City of San Antonio  
**TRANSPORTATION AND CAPITAL IMPROVEMENTS**

**ADDENDUM No. 1**

**PROJECT NAME: McCullough Avenue Area Drainage – ID NO.:40-00327**

**DATE: April 19, 2016**

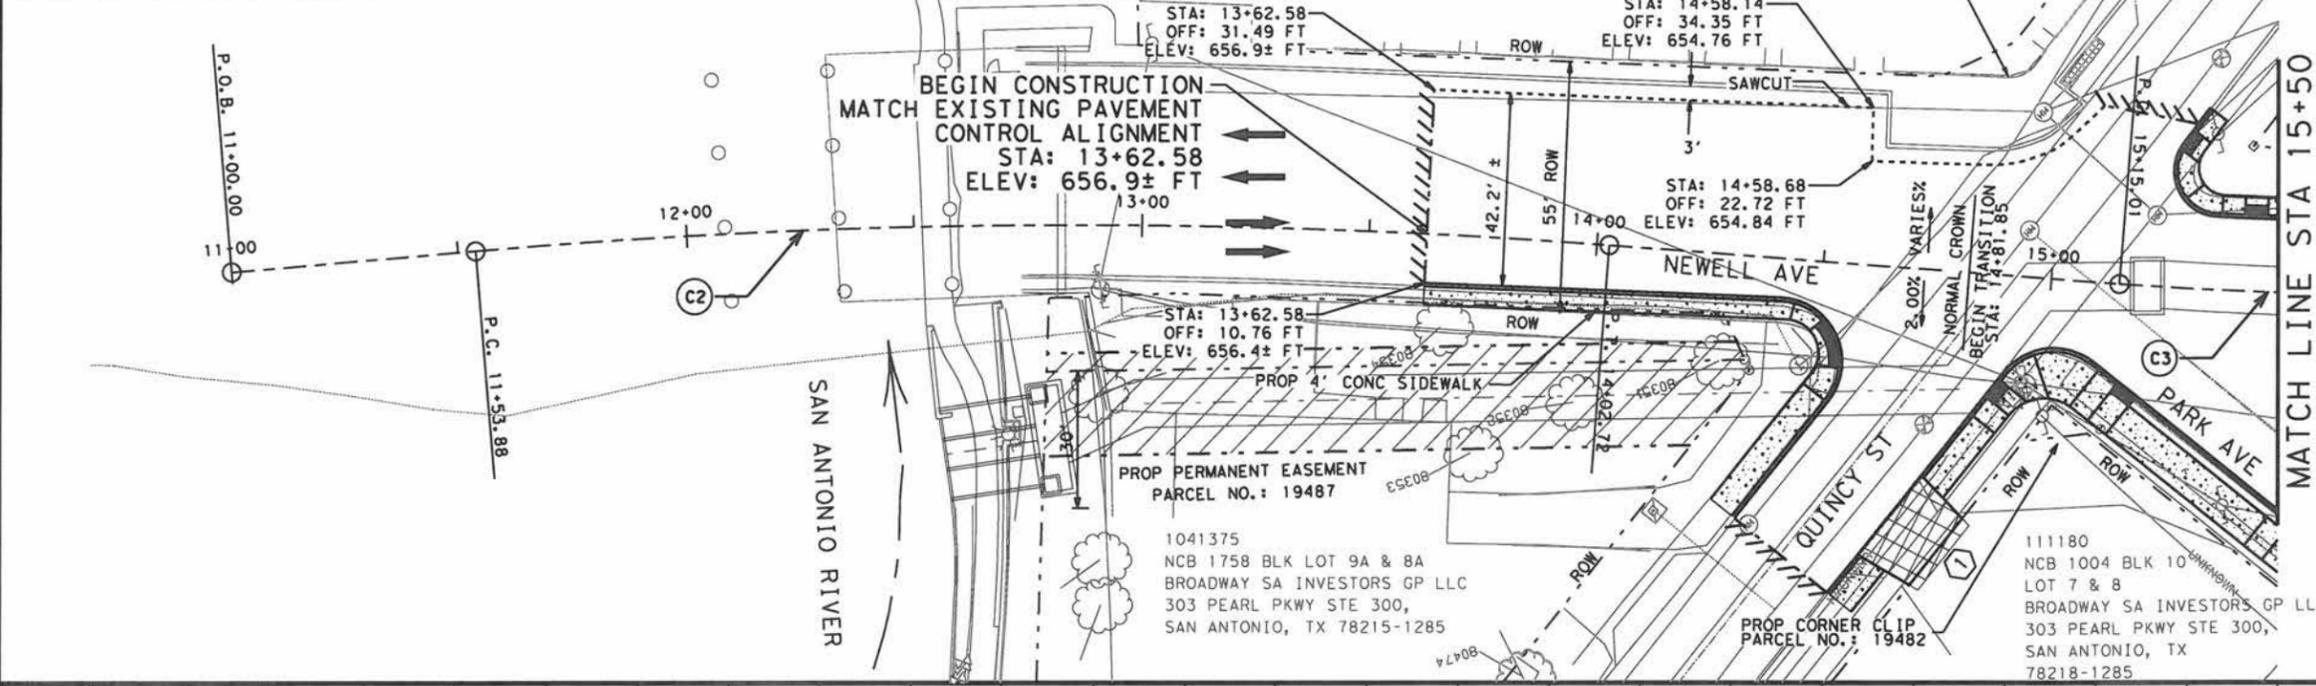
**Response: BID ALTERNATE No. 1 is removed.**
3. Question: Note 2 on Sheet 36 indicate that up to two Phases can be worked at one time. Please confirm that this is possible.

**Response: This statement has been removed and revised on Sheet 36.**
4. Question: For phases where the road is closed, can construction materials be stored in the work area?

PROPOSED 30' X 5' ROCK RIPRAP (6" MINIMUM DEPTH) W/ 3" COBBLE STONE & 24" X 6" TOEDOWN ALL AROUND

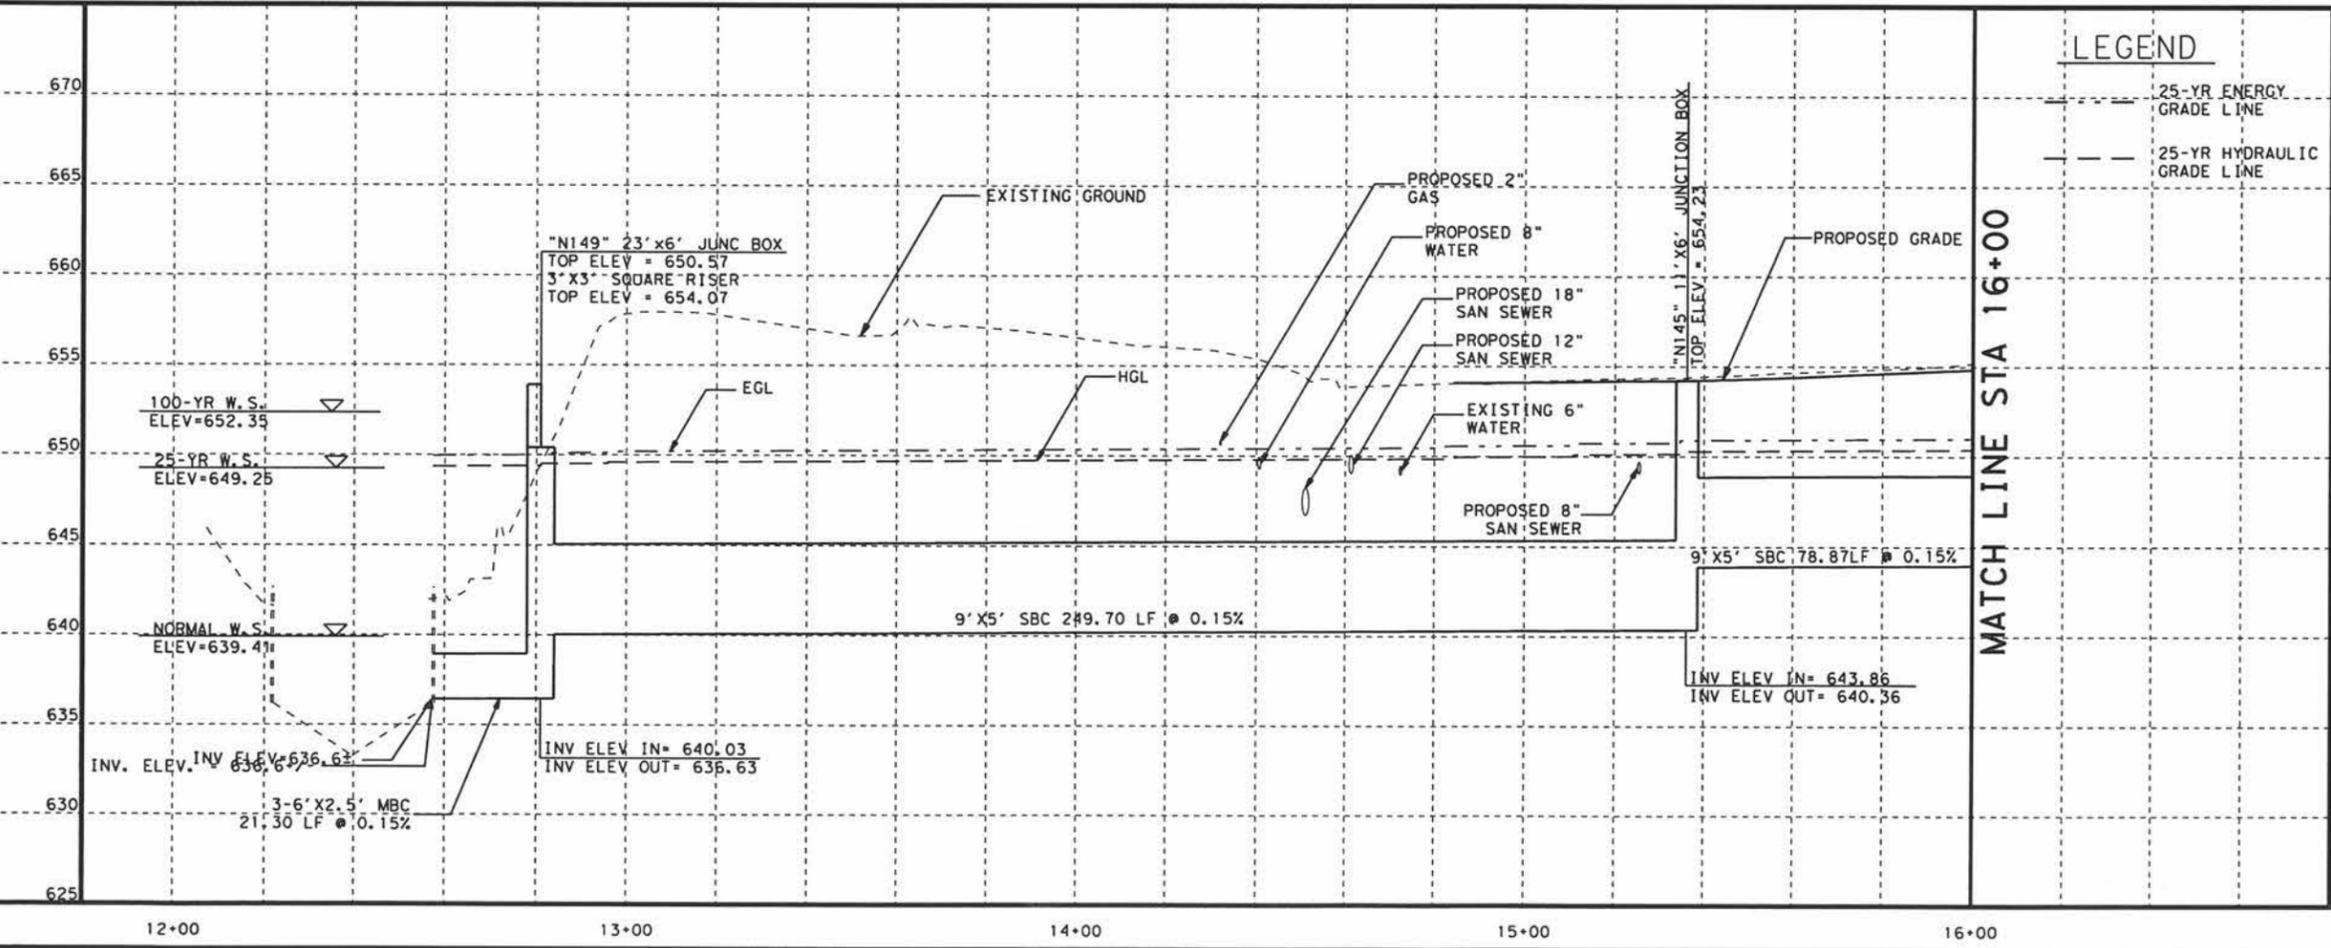
5. Question: How is the 30'x5'x8" minimum depth riprap shown on Sheet 114 measured and paid?  
**Response: This should be 30'x5'x6". It is to be paid by TxDOT Item 432-6022 - RIPRAP (STONE COMMON) (DRY) (6IN) by the cubic yard. The plan sheet has been revised, and the summary sheet is updated to reflect the change.**

SECTION A-A  
NTS

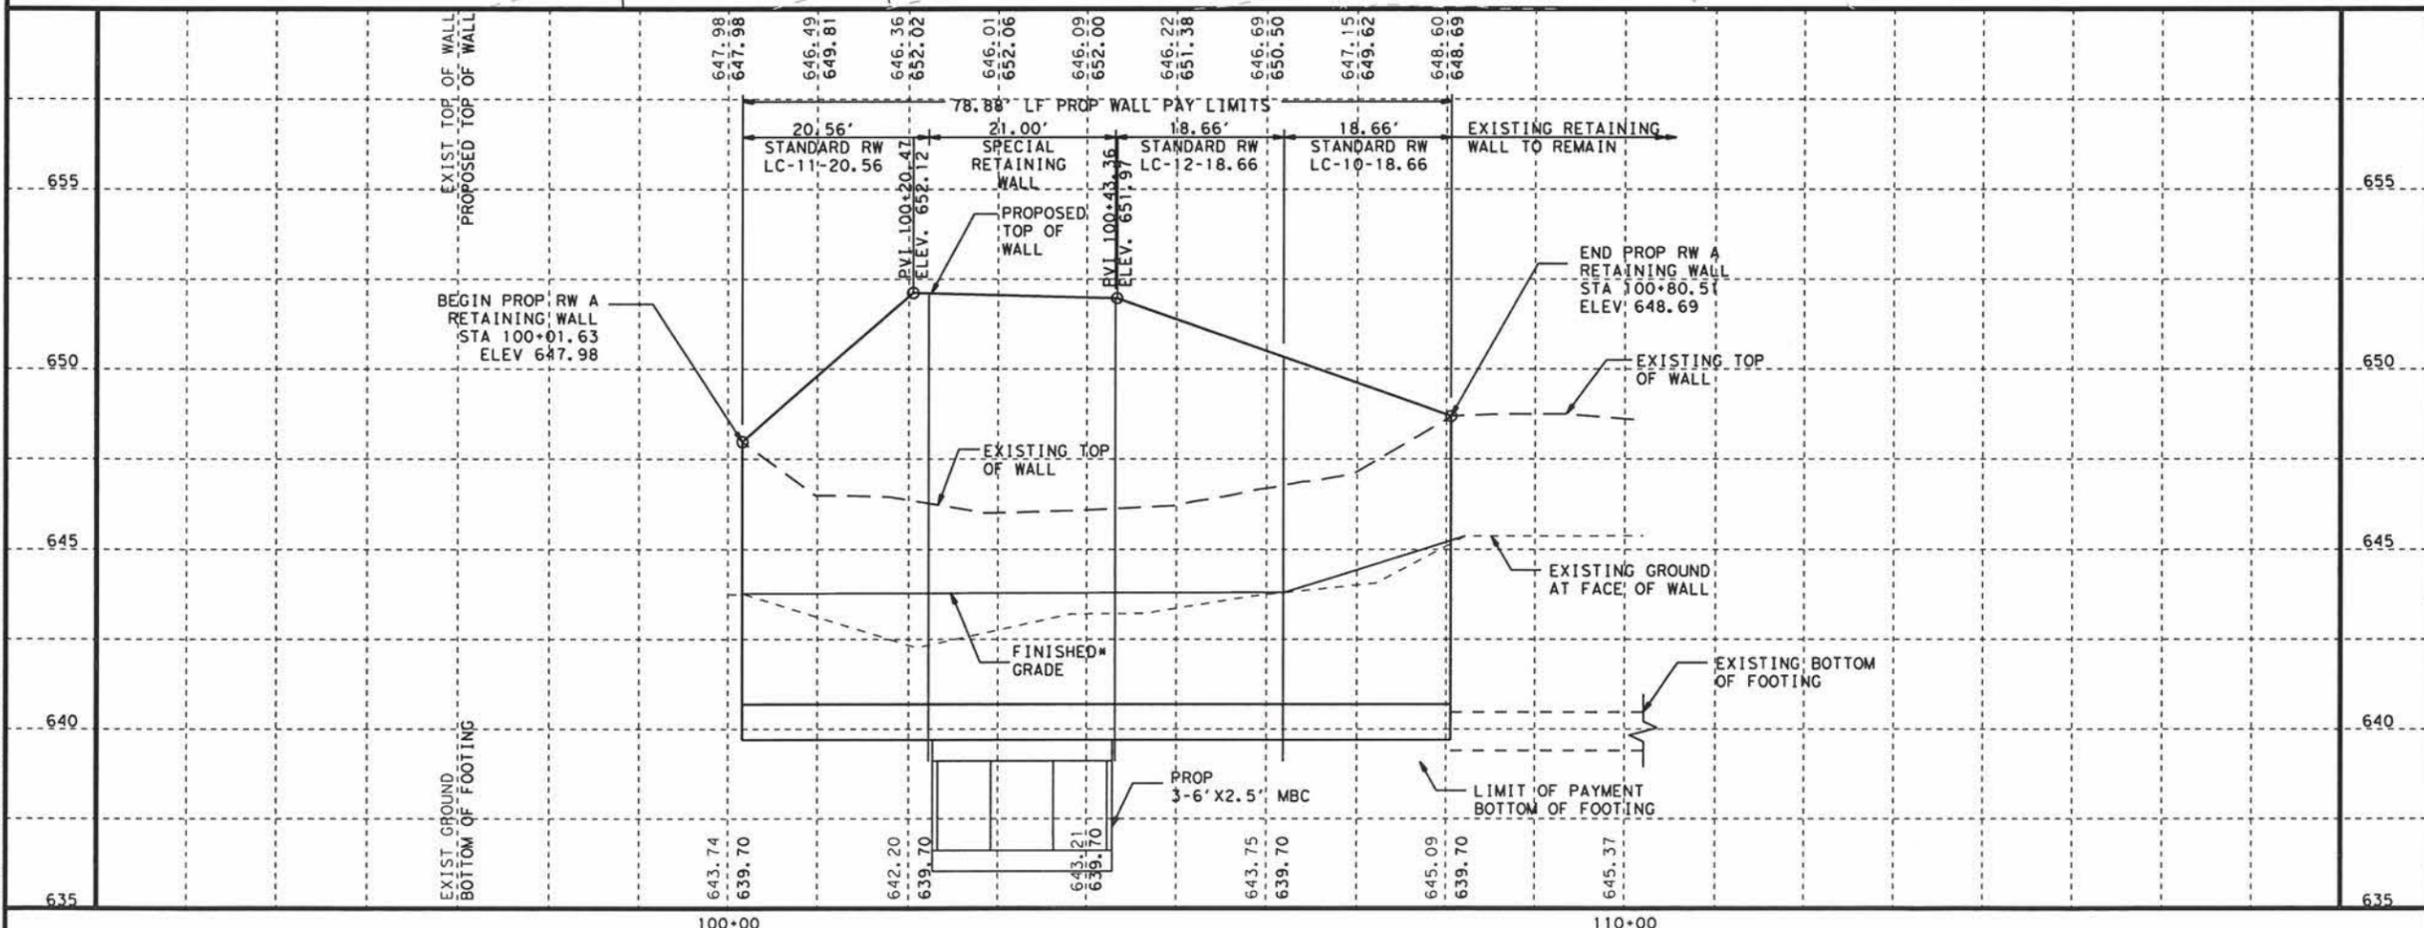
**Response: These will be provided.**
10. Question: For Section A-A on Sheets 158 and 159, how is the Select Granular Fill measured and paid?  
**Response: Select Granular Fill is subsidiary to Retaining Wall construction, and will be paid under Item 423-6005. See clouded note on Sheet 166.**

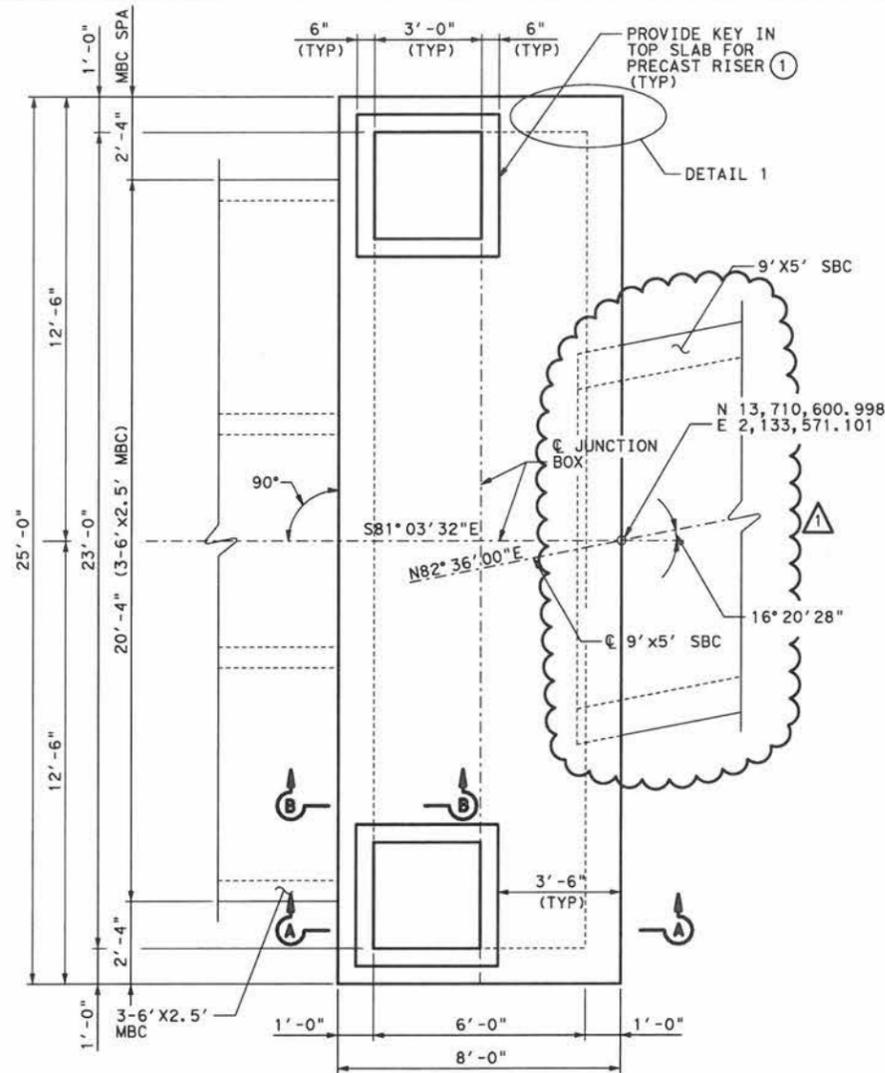
- **The temporary special shoring for TxDOT Item 403-6001 is removed. However, as shown in Sheet 161, some form of temporary special shoring in the San Antonio River area may be needed. Since it is unknown what type of cofferdam will be installed for this area, any temporary special shoring required for the work in the area of the river, in order to maintain the integrity of the Newell Bridge or the approach roadway is subsidiary to the cost of TxDOT Bid Item 403-6006 - TEMPORARY SPL SHORING (COFFERDAM).**

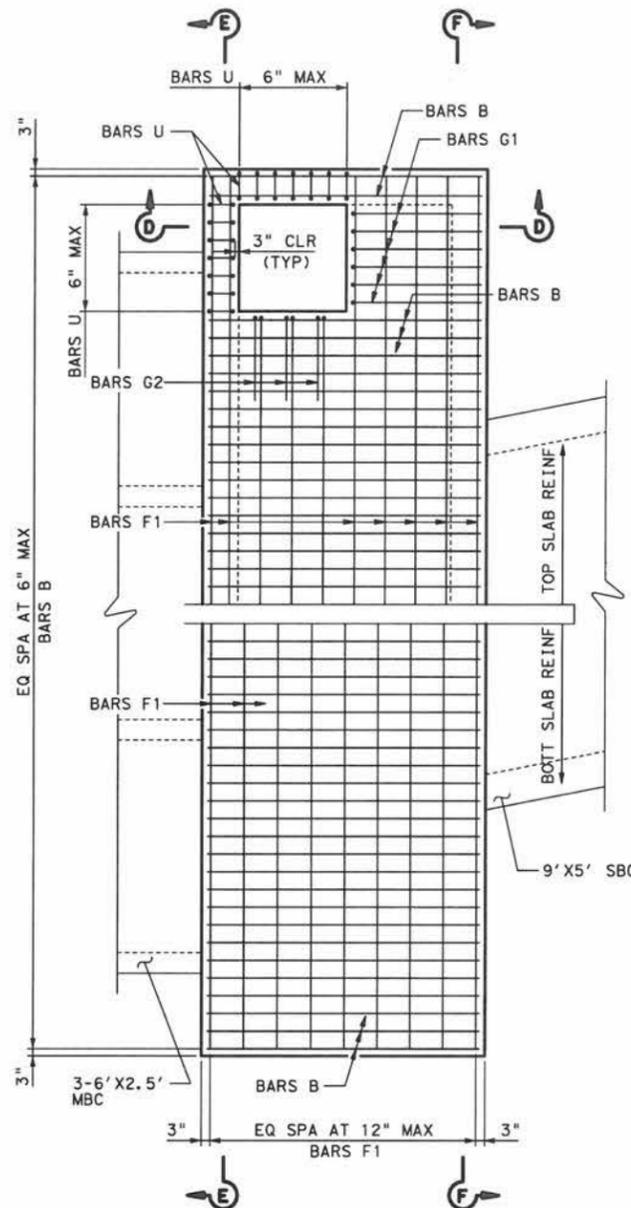
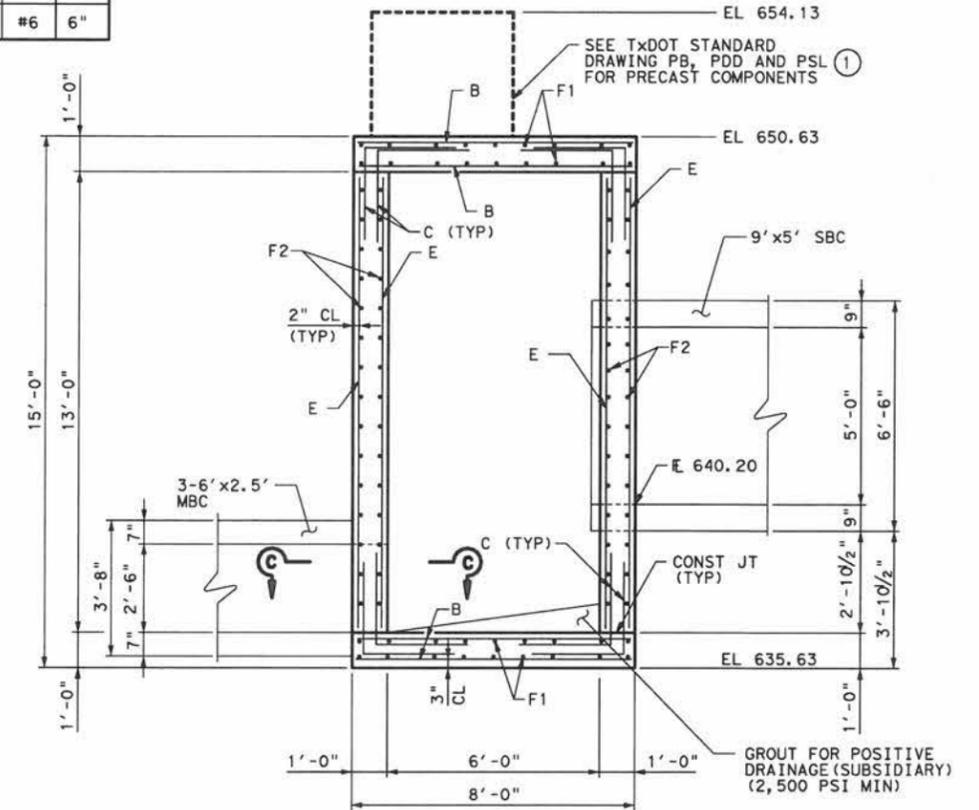
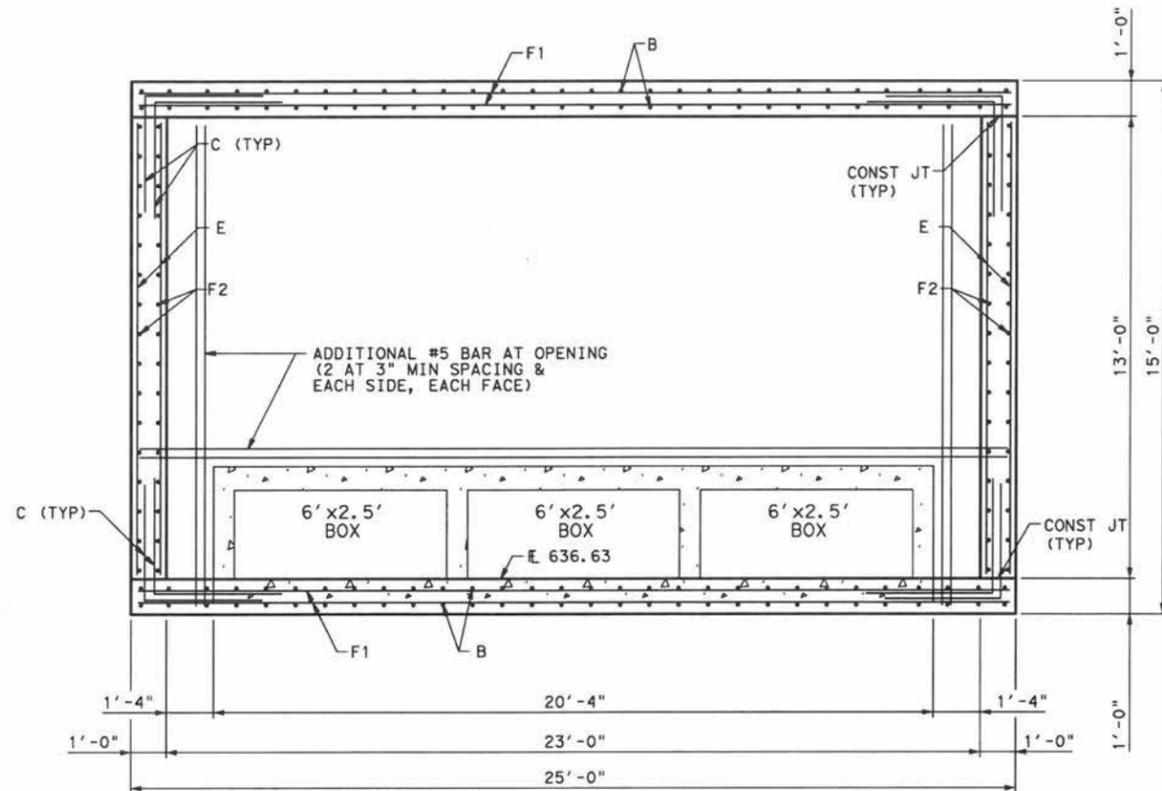
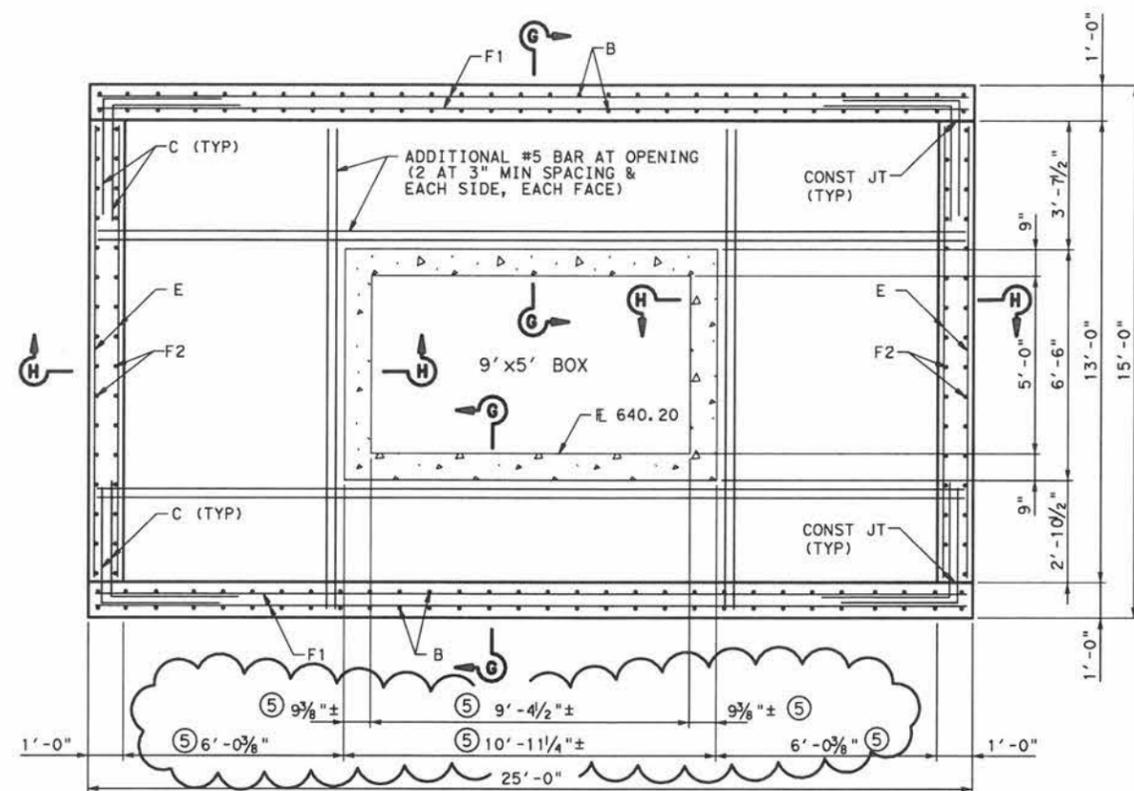
17. Question: Are there details available for the Special Junction Boxes?  
**Response:** *Sheet 114 and 120 revised for more clarification. See Sheet 169-170 for the Special Junction Box Details in the San Antonio River.*
